Agenda
City of Baldwin City, Kansas Planning Commission
Tuesday, July 9, 2019 – 7:00 p.m.

TO: Planning Commission
FROM: Ed Courton, Community Development Director
DATE: July 5, 2019
PROJECT: Firetree Estates Phase 6A, Preliminary Plat

Re: Preliminary Plat Review
Firetree Estates Phase 6A, Baldwin City, KS

Firetree Estates Phase 6A Preliminary Plat

PRELIMINARY PLAT
FIRETREE ESTATES PHASE 6A
RIDGE ROAD
BALDWIN CITY, KANSAS

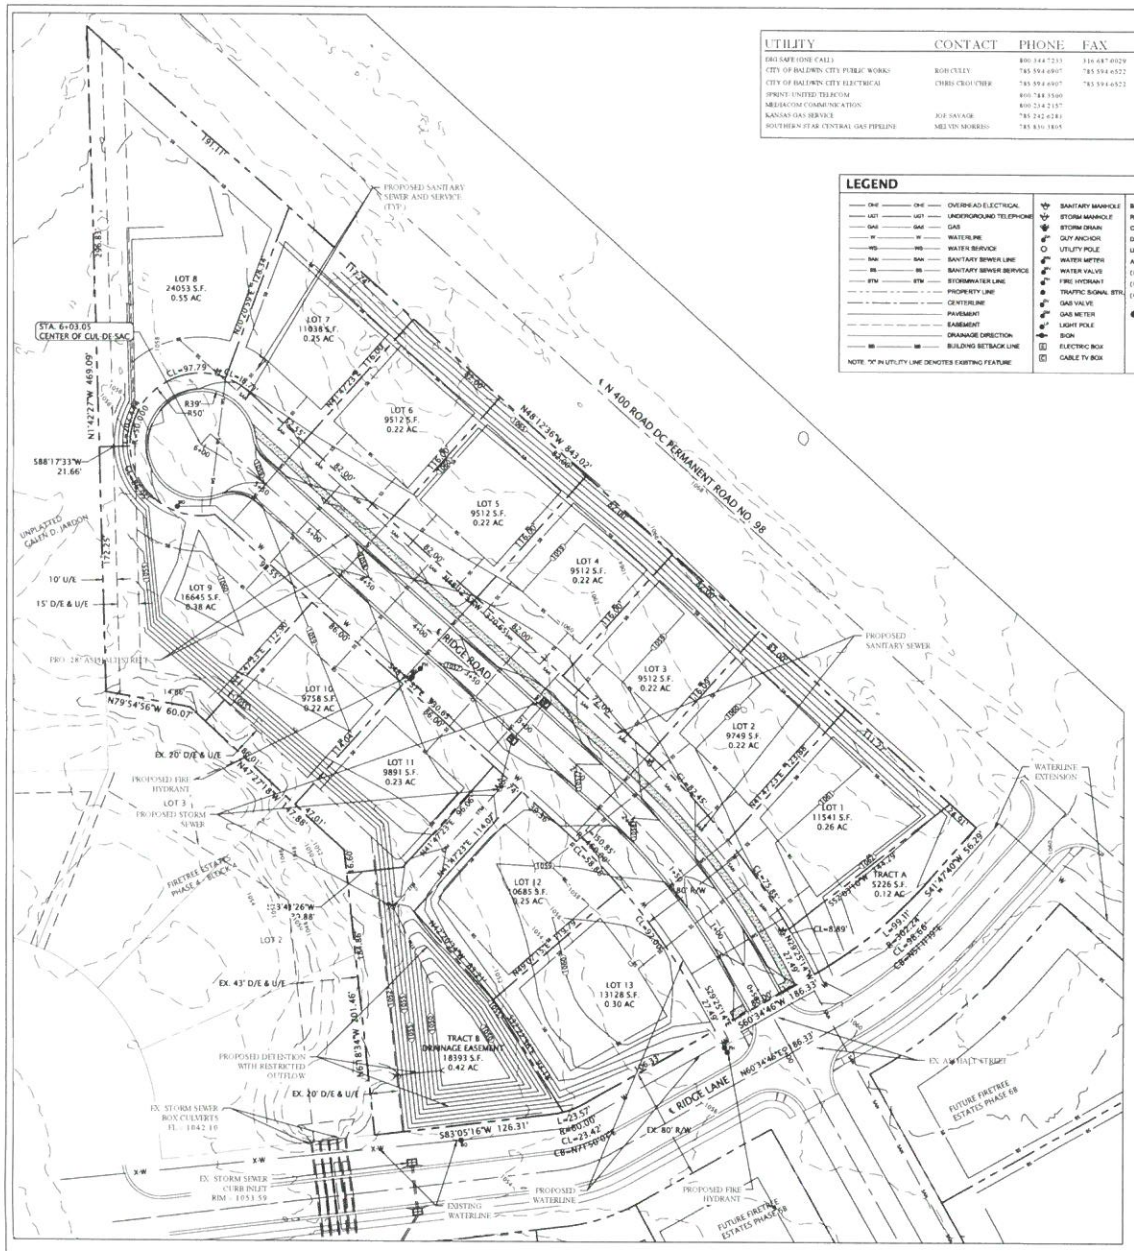
1. No utility easements are shown for privately owned utilities on Lots 1-7, 12 and 13. Is it the developer's intent to place all utilities in the Ridge Road right-of-way?

2. We suggest placing minimum building low opening elevations on Lots 8 thru 13 and basing those elevations on the 1% chance rainfall event (100-year) plus 1 foot of freeboard abutting said lots for the drainage channel and/or detention pond on the back of the lots.

3. The waterline along Ridge Lane should be extended to N 400 Road and then to the southeast to provide a loop into the City's water system on N. 6th Street and a second point of service to this development.

4. Locate the proposed Ridge Road waterline 10 feet from the right-of-way line rather than the 4.5 feet shown on the preliminary plat.
5. The water service near the Sta. 2+25 (Left) is within 10 feet of the manhole. Consider shifting the manhole a sufficient distance to obtain 10 feet of clearance or consider realigning the water service to Lots 2 and 3 (also see related comment #6 below).

6. The length of sanitary sewer between the manhole at Sta. 2+25 (Left) and the manhole at the end of the cul-de-sac exceeds 400 feet. Consider moving the sanitary sewer manhole at Sta. 2+25 (Left) northwest to keep sanitary sewer runs at 400 feet (maximum) in length.

7. A utility easement (U/E) will be needed along the from of Lots 1 thru 8 for future maintenance of the sanitary sewer. Also, show sufficient U/E on the front of Lot 8 for the manhole shown on the lot. The size of U/E needed will be contingent on the depth of the sanitary sewer line.

1. I was waiting on feedback on desired utility easements. 7.5' U/E has been added to the front of all lots.
2. Minimum Elevation of Building Openings (MEBO) has been added to Lots 9-13
3. Comment noted. Proposed waterline location shown.
4. Waterline location changed to 10' off R/W.
5. Water Service location changed.
6. Sanitary Sewer Manhole location changed. SS line now less than 400'.
7. See note 1.

Hydraflow IDF Curves

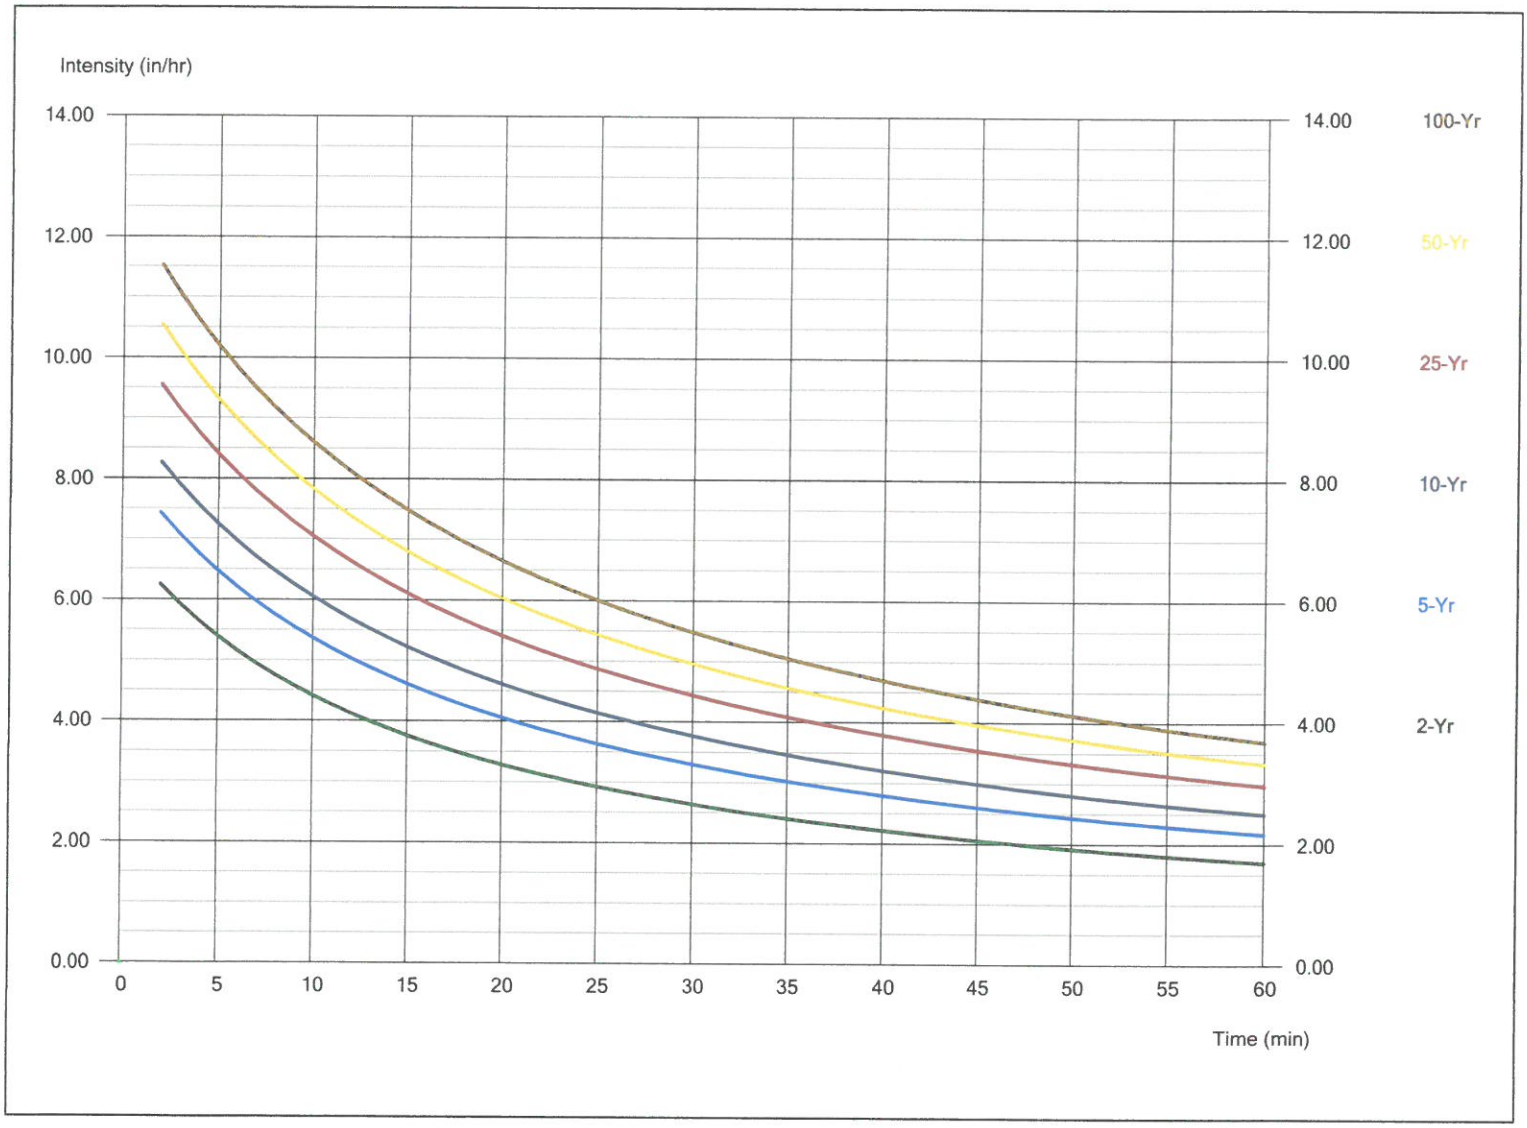
1. Baldwin City's *Manual of Practice for Water, Sewer, Residential Streets and Storm Drainage*, Section 5606.4.B. "Release Rate" limits the maximum release rate from any development in the 100-year and more frequent storms to 1.8 cfs per tributary acre. The release rate of 1.8 cfs per acre applied to this 5.23-acre development equates to 9.4 cfs. The proposed stormwater release rate is 14.01 cfs which exceeds the 1.8 cfs per acre but is lower than their calculated estimate of undeveloped stormwater runoff rate of 27.97 cfs. Baldwin City will either need to provide a variance for the development's stormwater release rate or the developer's Stormwater Management Plan will need to be revised.

2. Appendix B is labeled "Developed Conditions" but appears to match the undeveloped site conditions. Developer's engineer should provide confirmation/clarification that Appendix B is for undeveloped conditions (for the City's future reference to the report).
3. The report should include an Intensity-Duration-Frequency graph or table to document the rainfall intensity values used in the hydrograph analysis.
4. The future submittal of public improvement plans should include a grading plan and outlet structure details, including erosion control, for the proposed detention pond to confirm the improvements conform to the basis of design/analysis in the report.

1. The maximum release rate does not meet the 1.8 cfs/ac, but it should be noted that the most recent APWA Specifications & Design Criteria Section 5600 Storm Drainage Systems & Facilities Subsection 5608.4(c) allows for 3.0 cfs/ac discharge. APWA recommended 3.0 cfs/ac in years past and for a period of time change that to 1.8 cfs/ac, but changed it back to 3.0 cfs/ac because it was too stringent on small developments. Note, the discharge from the pond is only 3.87 cfs which equates to 0.74 cfs/ac. The peak discharge is mostly due to the undetained run-off around the perimeter mostly undeveloped areas. These small areas amount to 1.93 cfs/ac.
2. Appendix B is mislabeled, it should read "Undeveloped Conditions".
3. IDF graph and table provided.
4. Noted.
